ORDINANCE NO. 072 - 2021

AN ORDINANCE CHANGING THE ZONE FROM A NEIGHBORHOOD BUSINESS (B-1) ZONE TO A HIGH DENSITY APARTMENT (R-4) ZONE, FOR 1.56 NET (1.86 GROSS) ACRES, FOR PROPERTY LOCATED AT 1009 AND 1017 WELLINGTON WAY. (RTA FAMILY TRUST; COUNCIL DISTRICT 10).

RECOMMENDATION OF THE
URBAN COUNTY PLANNING COMMISSION
OF LEXINGTON AND FAYETTE COUNTY, KENTUCKY

IN RE: **PLN-MAR-21-00001: RTA FAMILY TRUST** – a petition for a zone map amendment from a Neighborhood Residential (B-1) zone with conditional zoning restrictions to a High Density Apartment (R-4) zone, for 1.56 net (1.86 gross) acre, for properties located at 1009 & 1017 Wellington Way. (Council District 10)

SCHROYER PROPERTY LOTS 3 & 4, 1009 & 1017 WELLINGTON WAY, LEXINGTON, KY. PRELIMINARY DEVELOPMENT PLAN.

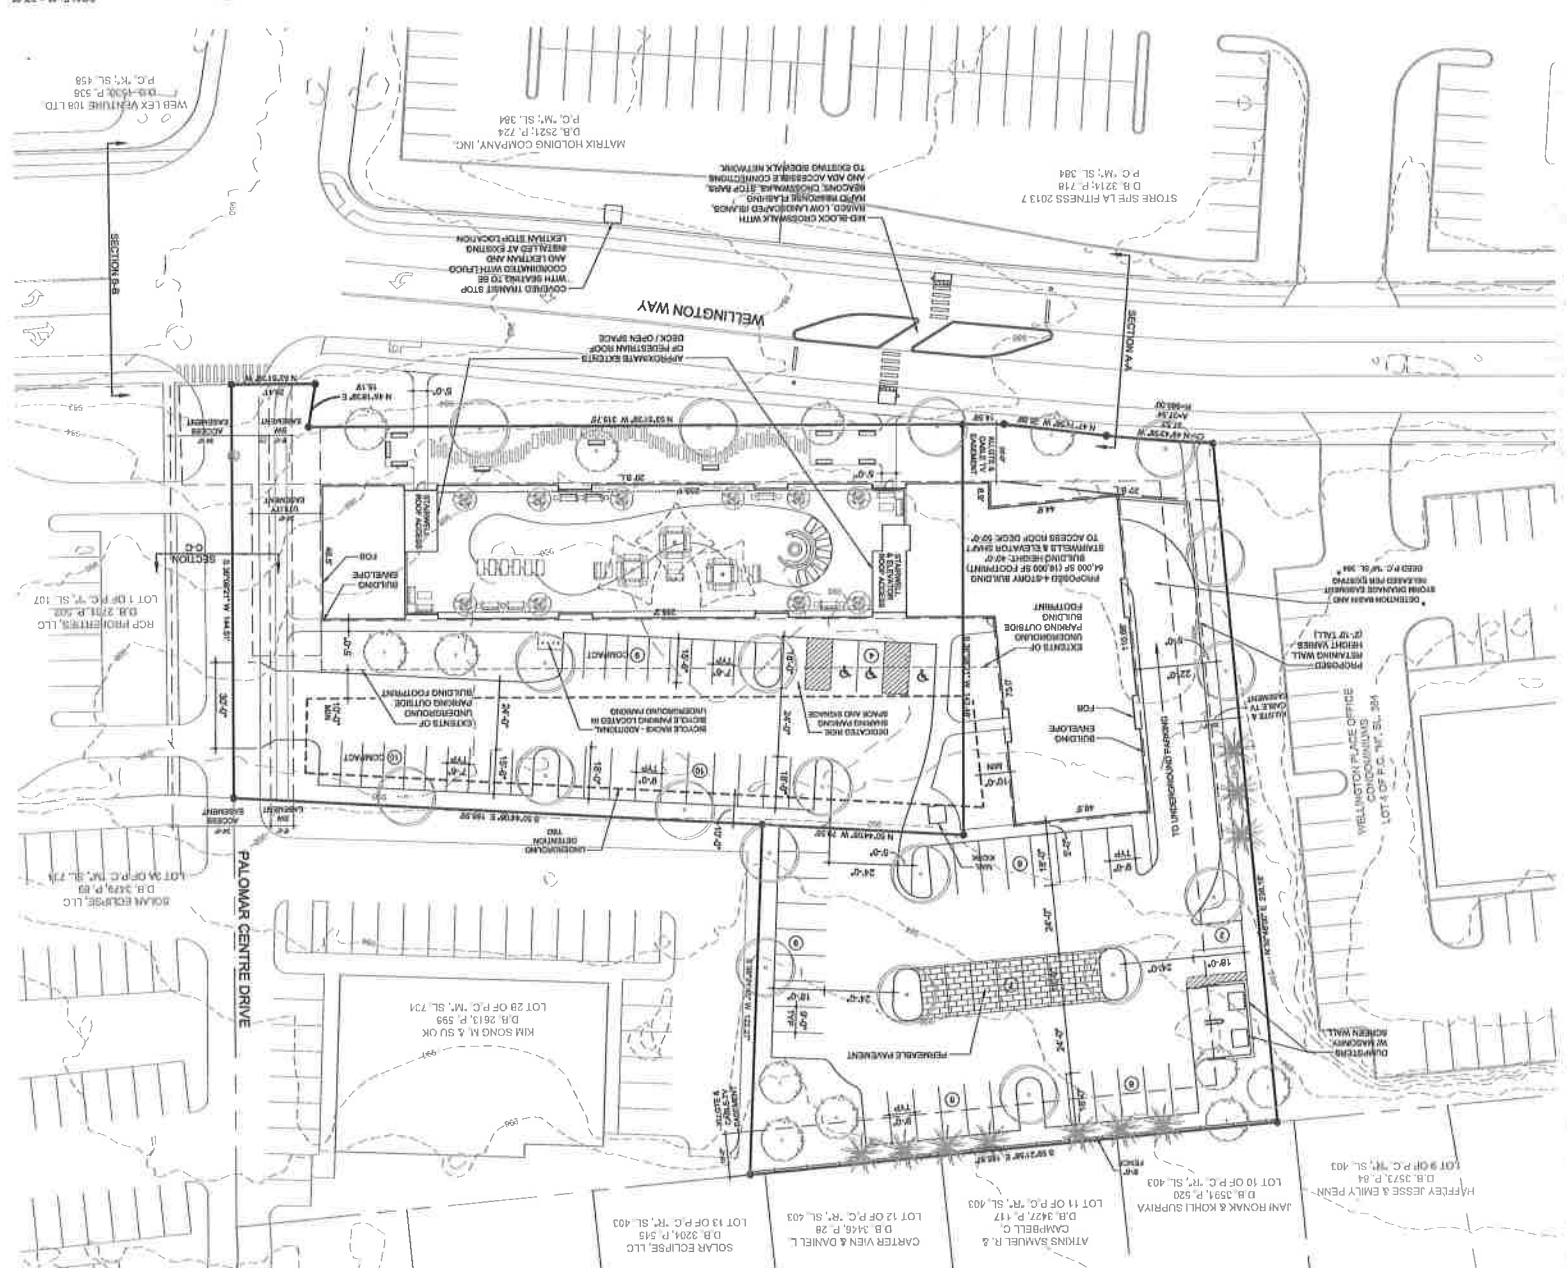
The applicant has not addressed the Multi-family Design Standards with their letter of justification nor the development plan. The applicant must address the site planning, open space and landscaping, and architectural design of Appendix A of the 2018 Comprehensive Plan. Special attention should be paid to the access to the structure and how the open space that is planned for the rooftop will be designed. Elevation drawings or renderings may be submitted to illustrate how the application is seeking to meet the Multi-family Design Standards.

The current development plan depicts a single access point to the structure from Wellington Way. The front building plane along the Wellington Way frontage is approximately 270 feet in length. The applicant should include additional pedestrian access points to the structure, which will also play a major role in the activation of the ground level of the structure.

The current development plan provides limited connections to the public right-of-way along Wellington Way and has limited articulation along the front wall plain. The applicant should review the Multi-family Design Standards for guidance as to how to best activate the ground level of the proposed structure.

The applicant indicates that the proposed development will act as a buffer, softening the transition from the shopping center to the single-family neighborhood to the rear. In an effort to further reduce the impact on the nearby single-family residences, the applicant has proposed to provide pedestrian scale lighting to minimize light disturbance on the adjacent properties, as well as enhanced screening between the property and the adjacent lots. The applicant should provide greater detail as to how this will be achieved.

Within the applicant's letter of justification, they reference the inclusion of trees as satisfying the implementation of green infrastructure. However, green infrastructure is defined within the Comprehensive Plan as "infrastructure and stormwater control design approaches and technologies that mimic the natural hydrologic cycle processes of rainfall infiltration, evapotranspiration and reuse (Pg. 342)." To the extent possible, the applicant should seek to include green infrastructure on site.

Though the applicant is proposing to provide multi-family residential into an area that is primarily commercial in use, greater detail as to how the development will be integrated to the commercial areas located across Wellington Way must be discussed. Currently, the only access point it located at the unsignalized intersection of Wellington Way and Palomar Center Drive. This intersection is a transition where the roadway narrows from five (5) lanes to three (3) lanes. The applicant is showing the creation of a crosswalk at this location. The applicant should work with the Division of Traffic Engineering and the Division of Planning to explore alternative solutions to provide the safest connection point between their proposed development and the commercial development located across Wellington Way.

Within the applicant's letter of justification, they reference the location of the transit stop across from the proposed development and its utility. This stop is also noted on the development plan, but indicates that it will be enhanced, which also allows for a ten (10) percent reduction in the amount of required parking. If the applicant is seeking to provide a shelter at this location, they should work with the Division of Planning, Transportation Section, and LexTran to discuss the design and viability of such a shelter.

The applicant should work with the Division of Traffic Engineering and the Division of Planning to review the proposed plan and explore alternative solutions to provide the safest connection point between their proposed development and the transit stop located across Wellington Way.

The applicant indicates that they will take into consideration the ever changing methods of ridesharing and accommodate those uses. They should depict how those considerations would be formulated on the development plan, including designating specific parking spaces for this purpose.

The applicant should provide greater information as to the orientation and location of the open space on the proposed development. This should include where on the rooftop the open space will be located and potential amenities. The form of the rooftop open space is of particular concern as it is the subject of the associated variance request.

The applicant has provided staff with a tree planting plan. However, there is concern regarding the viability of the clustering of large trees throughout the site. The applicant should work with staff to ensure the survivability of the proposed larger trees, specifically the clustered areas, to meet the 30% tree canopy requirement.

3. **A-DS5-4** - DEVELOPMENT SHOULD PROVIDE A PEDESTRIAN-ORIENTED AND ACTIVATED GROUND LEVEL. PROPOSED BUILDING HAS BEEN LOCATED TO REINFORCE STREET FRONTAGE. BUILDING WILL BE CONSTRUCTED WITH MULTIPLE COLORS AND MATERIALS AND WILL ALSO FEATURE MULTIPLE BUILDING ARTICULATIONS. TWO PROMINENT, VISIBLE ENTRY WAYS HAVE BEEN CENTRALLY LOCATED ON THE BUILDING TO ALLOW RESIDENTS DIRECT ACCESS TO WELLINGTON WAY. PLAZA SPACE AND SEATING HAS BEEN ADDED AT BOTH ENTRANCES TO REINFORCE ENTRYWAYS AND MAKE THEM INVITING SPACES. REFER TO ARCHITECTURAL RENDERING PAGE.

4. **A-EQ3-1** - DEVELOPMENT SHOULD CREATE CONTEXT SENSITIVE TRANSITIONS BETWEEN INTENSE CORRIDOR DEVELOPMENT AND EXISTING NEIGHBORHOODS. PROPOSED BUILDING HAS BEEN LOCATED TO KEEP THE DISTANCE OF NEW STRUCTURE AS FAR AWAY AS POSSIBLE FROM ADJACENT RESIDENTIAL LOTS. ENHANCED EVERGREEN SCREENING WILL BE PLACED AT LESSEER INTERVALS THAN THE RECOMMENDED 40' SPACING TO PROVIDE THE MAXIMUM AMOUNT OF SCREENING BETWEEN PROPOSED DEVELOPMENT AND RESIDENTIAL LOTS. PEDESTRIAN SCALE LIGHTING (ALL FIXTURES 12' AND UNDER) WILL BE USED ON SITE TO MINIMIZE THE AMOUNT OF LIGHT DISTURBANCE TO SURROUNDING PROPERTIES. EXTERNAL SHIELDING DEVICES HAVE BEEN PROPOSED ON FIXTURES CLOSEST TO RESIDENTIAL LOTS TO FURTHER REDUCE THE AMOUNT OF LIGHT DISTURBANCE. REFER TO PHOTOMETRIC LIGHTING DIAGRAM.

5. **B-SU11-1** - GREEN INFRASTRUCTURE SHOULD BE IMPLEMENTED IN NEW DEVELOPMENT. PERMEABLE PAVEMENT WILL BE USED ON THIS SITE. REFER TO PLAN FOR LOCATION.

7. **A-DS1-1** - MASS TRANSIT INFRASTRUCTURE SUCH AS SEATING AND SHELTERS SHOULD BE PROVIDED / ENHANCED ALONG TRANSIT ROUTES. A COVERED SHELTER WITH SEATING HAS BEEN PROPOSED AT THE EXISTING LEXTRAN STOP ON THE SOUTH SIDE OF WELLINGTON ROAD. FINAL DESIGN OF TRANSIT SHELTER WILL BE COORDINATED WITH LFUCG PLANNING, TRAFFIC, AND LEXTRAN.

8. **A-DS1-2** - DIRECT PEDESTRIAN LINKAGES TO TRANSIT SHOULD BE PROVIDED. A MID BLOCK CROSSING WITH RAPID RESPONSE FLASHING BEACON AND RAISED, LANDSCAPED ISLANDS HAS BEEN PROPOSED FOR WELLINGTON WAY. THIS CONCEPT HAS BEEN COORDINATED WITH LFUCG BIKEPED AND TRAFFIC AND DEEMED A SAFE SOLUTION FOR PEDESTRIAN TRAFFIC TO ACCESS TRANSIT STOP AS WELL AS RETAIL BUSINESSES. THIS SOLUTION WILL NOT ONLY PROVIDE SAFE ACCESS ACROSS WELLINGTON FOR THIS DEVELOPMENT, BUT WILL BENEFIT ALL BUSINESSES TO THE NORTH OF WELLINGTON WAY. THIS SOLUTION WILL ALSO PROVIDE TRAFFIC CALMING ALONG WELLINGTON WAY.

11. **E-ST3-1** - DEVELOPMENT ALONG MAJOR CORRIDORS SHOULD PROVIDE FOR RIDE SHARING PICK UP AND DROP OFF LOCATIONS ALONG WITH CONSIDERATIONS FOR ANY NEEDED OR PROPOSED PARK AND RIDE FUNCTIONS IN THE AREA. A RIDE SHARING SPACE HAS BEEN LOCATED ON THE SITE AND WILL INCLUDE ASSOCIATED SIGNAGE. SPACE WILL BE USED FOR RIDE SHARING PICK UP / DROP OFF, FOOD DELIVERY, ETC. SEE PLAN FOR LOCATION.

12. **A-EQ7-3** - COMMUNITY OPEN SPACES SHOULD BE EASILY ACCESSIBLE AND CLEARLY DELINEATED FROM PRIVATE OPEN SPACES. COMMUNITY OPEN SPACE IS CENTRALLY LOCATED AND ADJACENT TO THE BUILDING FACE ON THE GROUND PLANE. ADDITIONAL OPEN SPACE IS LOCATED ON THE ROOF AND IS ACCESSIBLE BY TWO DIFFERENT ELEVATOR / STAIR TOWERS. GREENSPACE LOCATED WITHIN THE FRONT YARD SETBACK IS ALSO BEING UTILIZED AS GATHERING / OPEN SPACE, BUT IS NOT INCLUDED IN THE OPEN SPACE CALCULATION.

13. **B-PR7-2** - TREES SHOULD BE INCORPORATED INTO DEVELOPMENT PLANS; PRIORITIZE GROUPING OF TREES TO INCREASE SURVIVABILITY. TREES HAVE BEEN SHOWN ON THE PLAN. SPECIAL CONSIDERATIONS HAVE BEEN TAKEN TO STILL INCLUDE SOME GROUPINGS OF TREES, HOWEVER THESE TREES HAVE NOW BEEN SHOWN AS MEDIUM TREES TO ACCOUNT FOR SPACING AND LIVABILITY CONCERNS. THE 30% TREE CANOPY REQUIREMENT HAS BEEN MET AND CAN BE SEEN ILLUSTRATED ON THE TREE

Following continued discussion with staff, the applicant has submitted new materials to address those areas of concern. Included in this documentation is a color rendering of the updated plan view of the proposed development, with notations that directly refer to staff's concerns from the original staff report. These include increased access to the frontage of the building (A-DS5-3), a pedestrian-oriented and activated ground plan (A-DS5-4), the location of green infrastructure (B-SU11-1), direct and safe access to transit facilities and commercial amenities (C-LI6-1, A-DS1-1, A-DS1-2, A-EQ3-2, D-CO2-1), and clearly delineated open space (A-EQ7-3). The applicant's description of the open space and the associated materials submitted also removes the need for the proposed variance request for the subject properties.
